CITY OF UNLEY
COUNCIL ASSESSMENT PANEL

I write to advise of the Council Assessment Panel Meeting to be held on Tuesday 19 September 2023 at 6:00pm in the Unley Council Chambers, 181 Unley Road Unley.

Item No	Planning, Development Infrastructure Act Applications	Page
1.	3 Mitchell Street, Hyde Park – 23012676	4-30
2.	5 Glenferrie Avenue, Myrtle Bank - 21011428	31-335

ITEM 1**DEVELOPMENT APPLICATION - 23012676 – 3 MITCHELL STREET, HYDE PARK SA 5061**

Drawing Title
Proposed Elevations

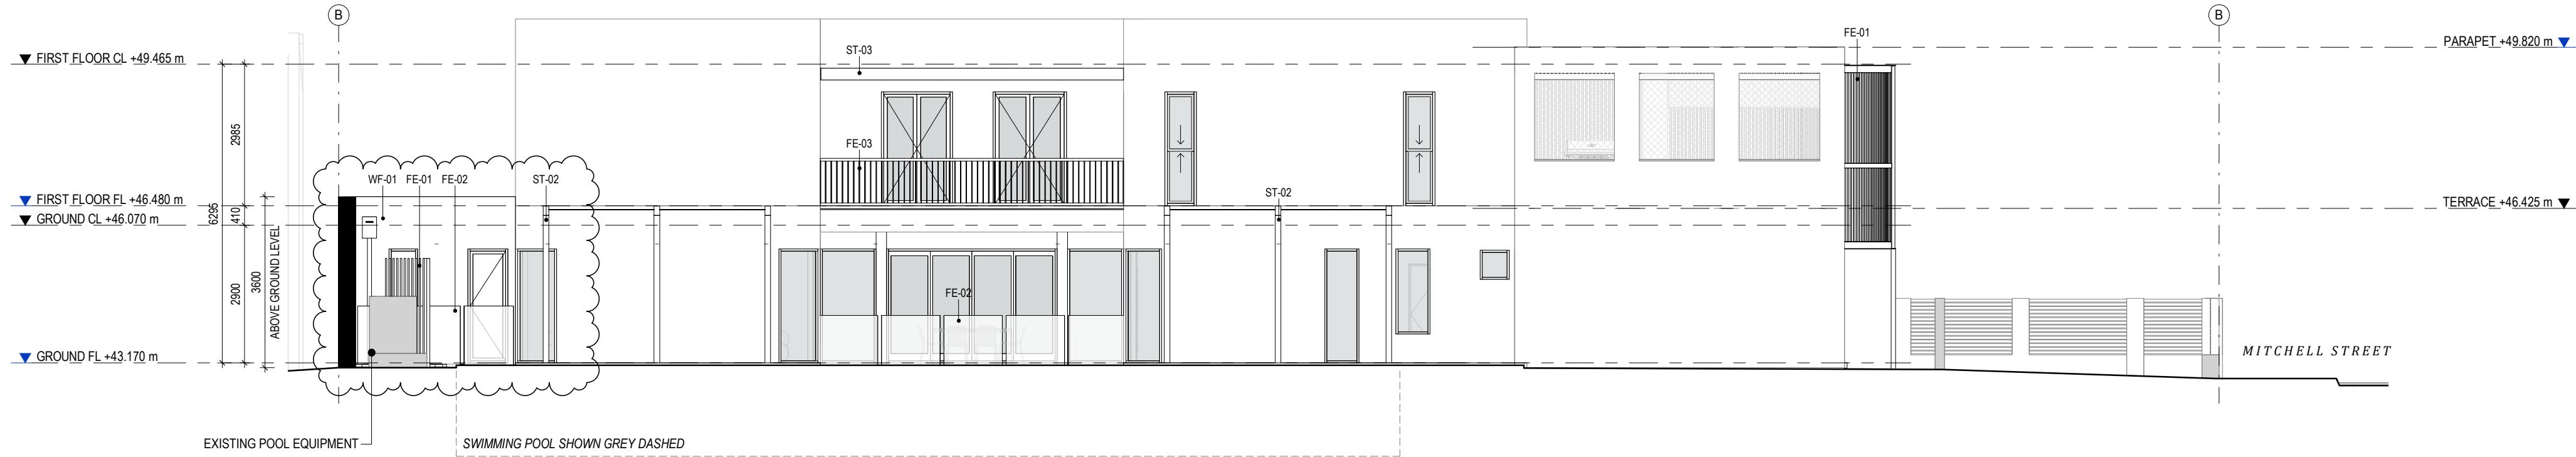
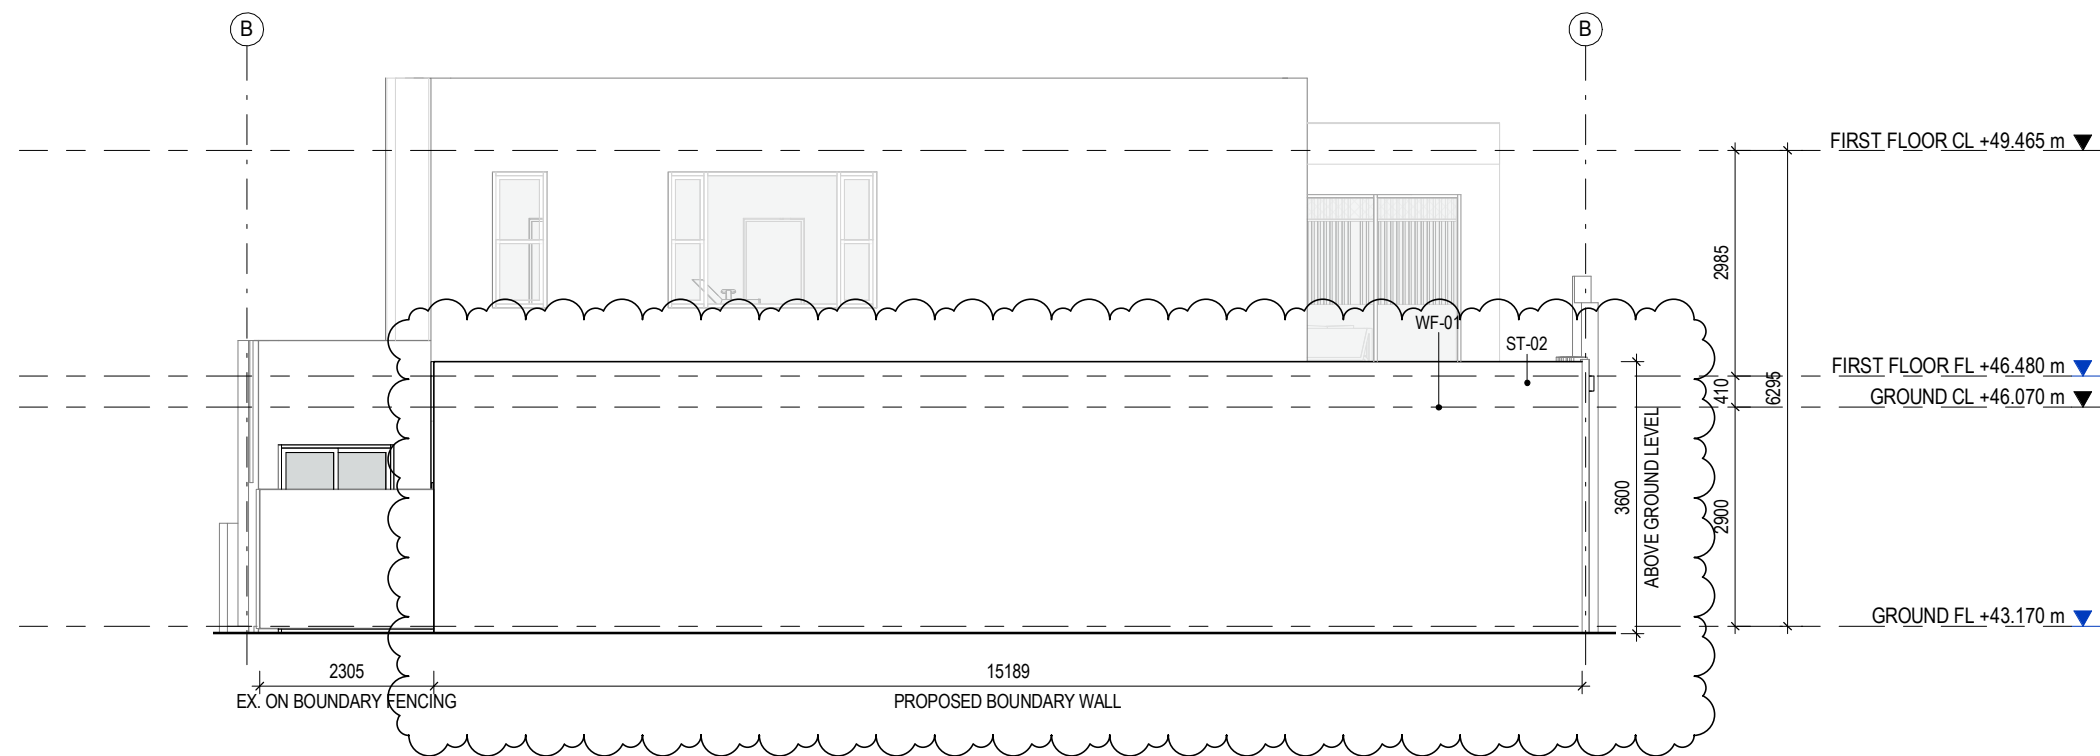
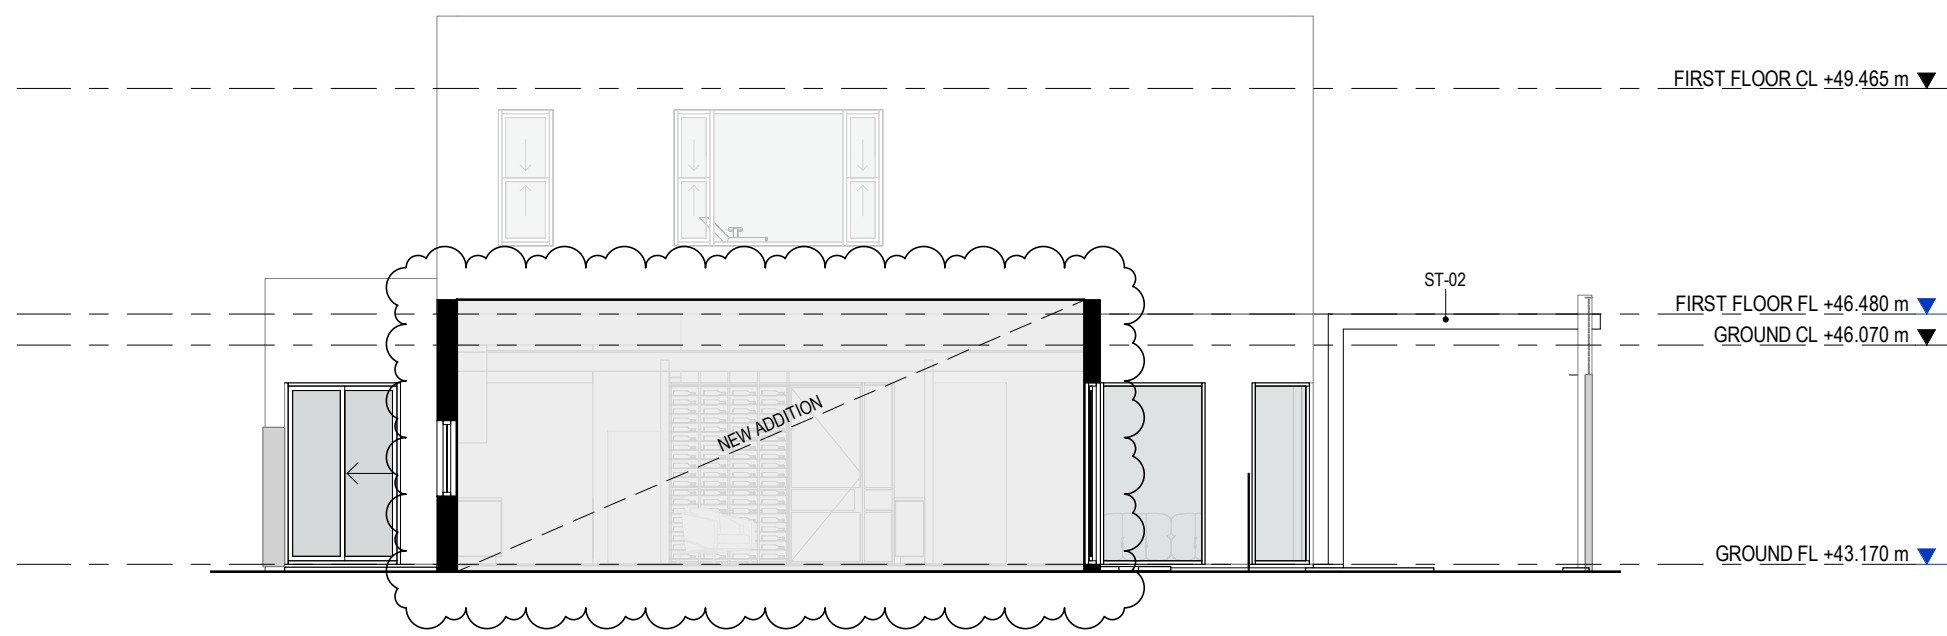
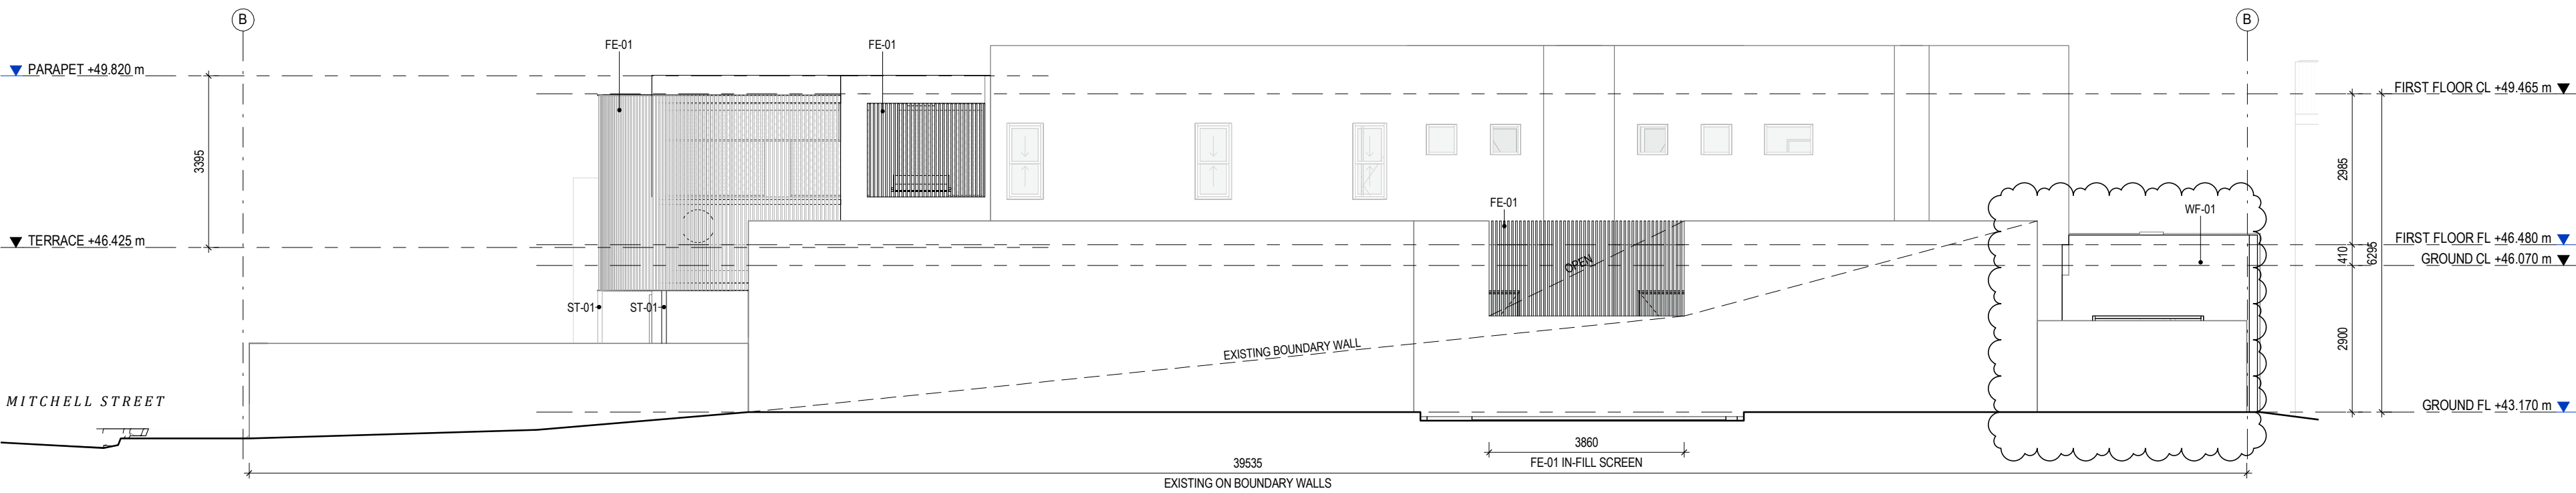
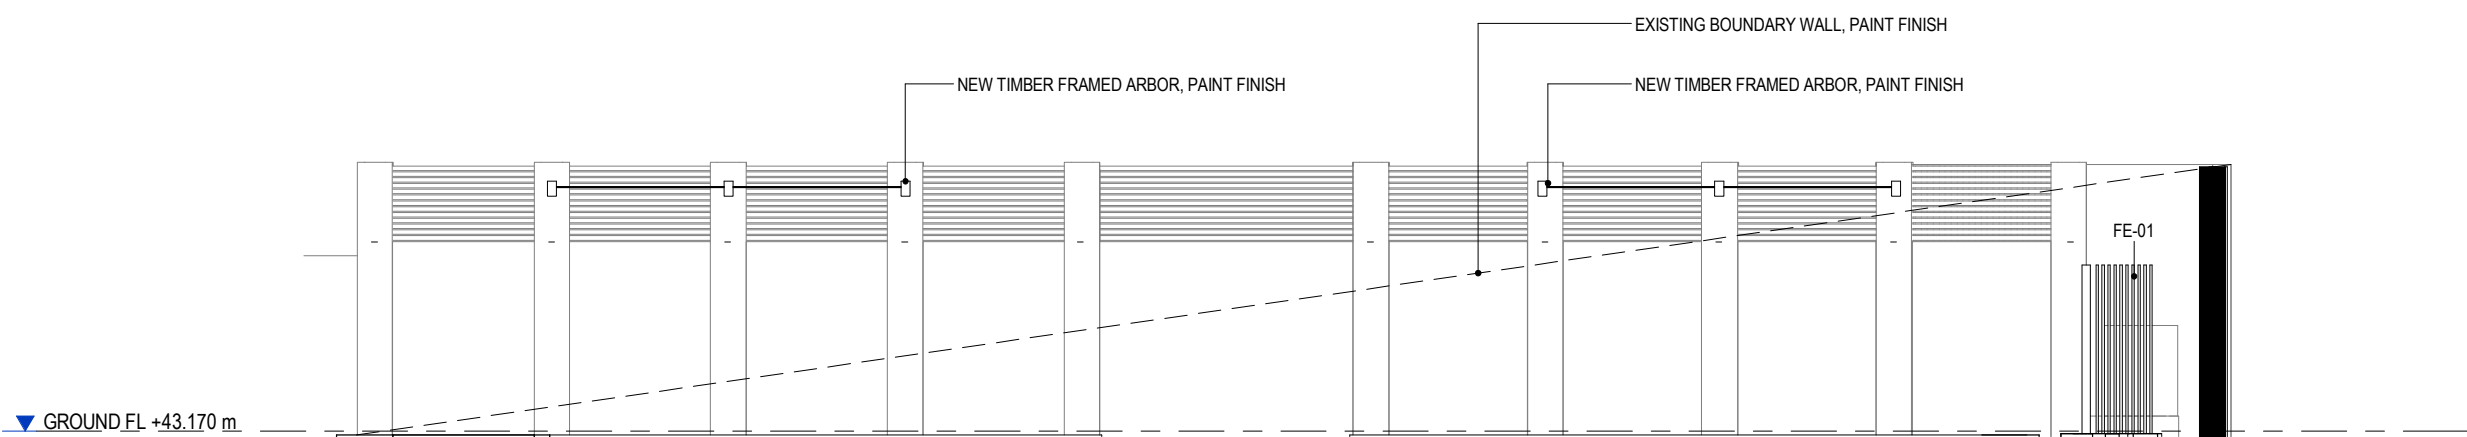
The dwelling addition is proposed to be sited on the rear southern boundary of the allotment for a length of 15.19m to a height of 3.6m. The 3.6m wall height is proposed to match in with the existing masonry fence sited on the eastern boundary. **PO 9.1** of the **Established Neighbourhood Zone** seeks for buildings to be offset from rear boundaries to provide separation between buildings in a manner that complements the established character of the locality to give adjoining properties reasonable access to natural light and ventilation. The corresponding **DPF** indicates that to satisfy the relevant **PO**, a minimum offset of 4m for the first building level should be provided.

The addition of the battens to the existing boundary wall will be of a height that will maintain the privacy and security of residents from the subject land and adjoining properties. In addition to the above, the battens will not unreasonably impact on the visual amenity of the adjoining land as light and ventilation to the adjoining properties will be maintained without exacerbating the visual mass of the masonry wall (refer to Figure 5). The proposal satisfies the intent of **PO 9.1** of **Design in Urban Areas**. Lastly, **PO 4.4** of **Historic Area Overlay** seeks:

- Amending the note on the southern elevation to reflect the proposed boundary wall.
- Clarification that the vertical infill battens along the western boundary will be fixed to steel supports and fixed to the existing masonry walls.
- Clarification that the vertical battens along the western elevation will replace the existing horizontal battens above the BBQ area.
- Confirmation that upper-level windows on the southern and western elevation are being retained.

3D perspective of the proposed development in relation to our clients' land at 9am on 21 June

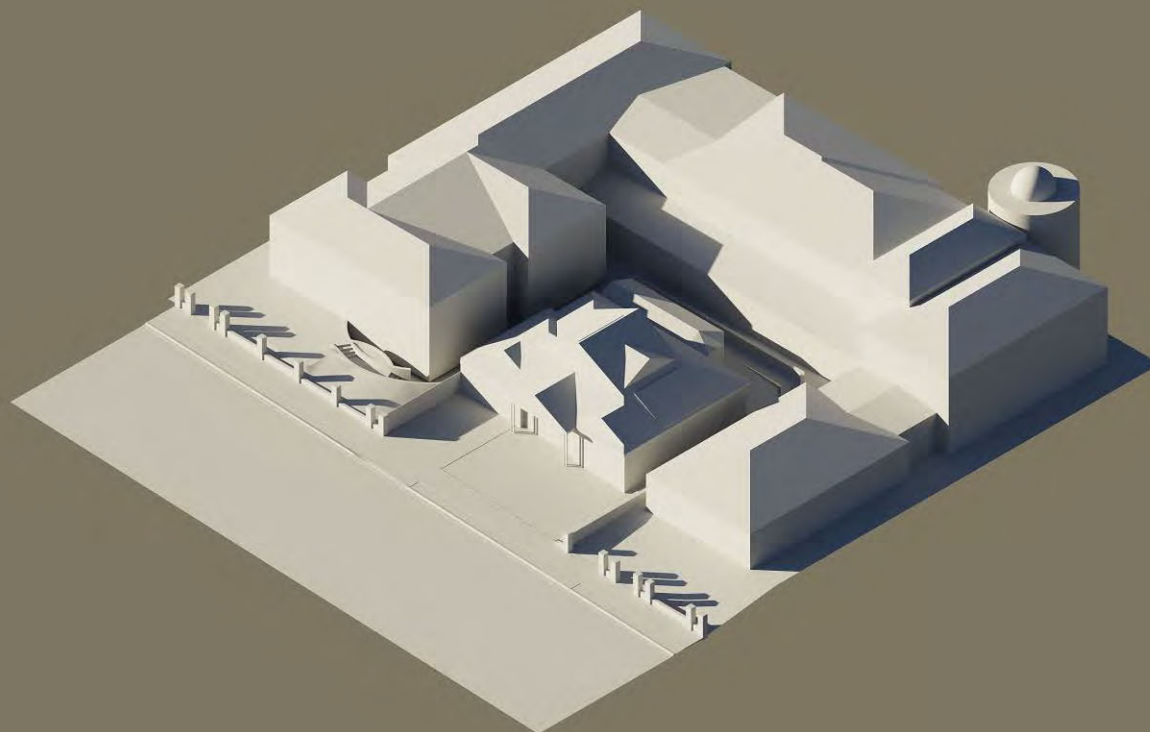
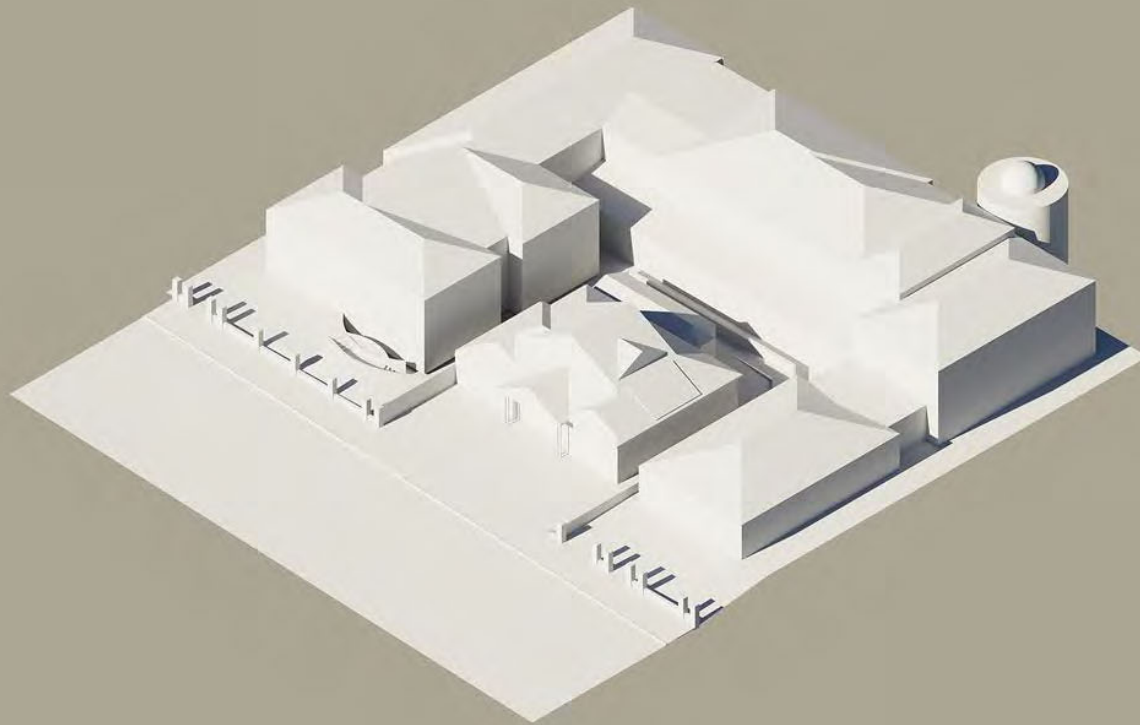
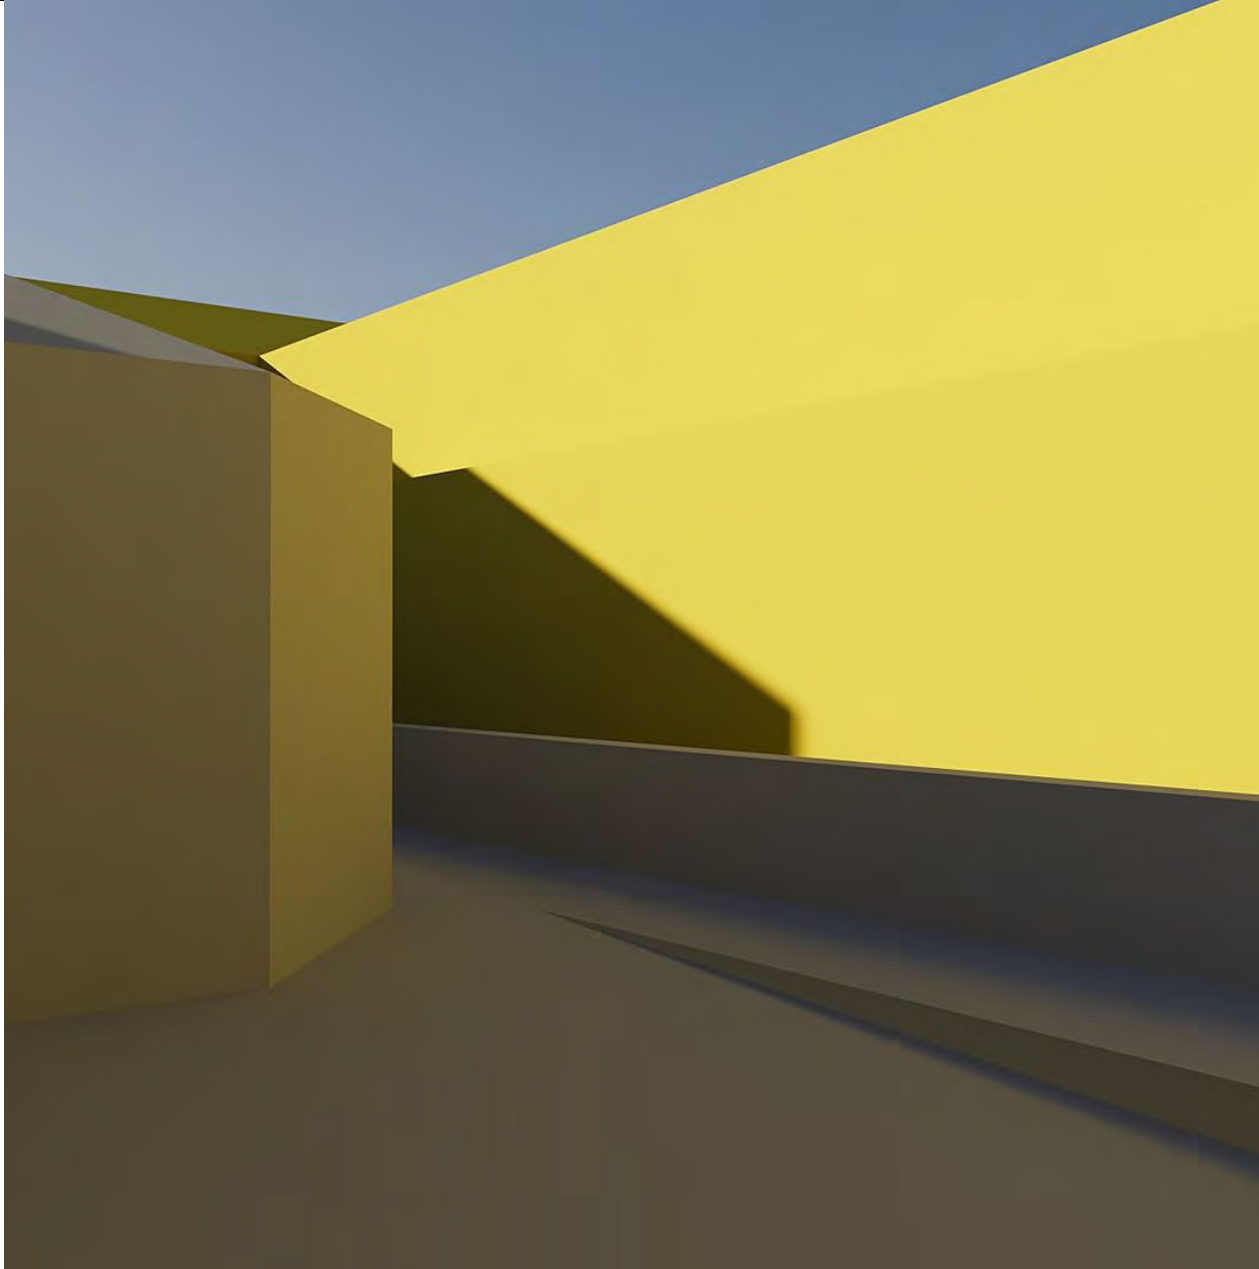
When one considers the Drawing SK-13, it is self-evident that the provisions in the Code will not be satisfied in terms of the access to sunlight and my clients' private rear space. My clients, in anticipation of the development, have established a gazebo in the south-eastern corner of the rear yard but it is clear from the images that the private open space in the south-western corner will not have access to sunlight as anticipated by the Code i.e. direct sunlight between 9.00am and 3.00pm for at least half of the existing ground level open space.
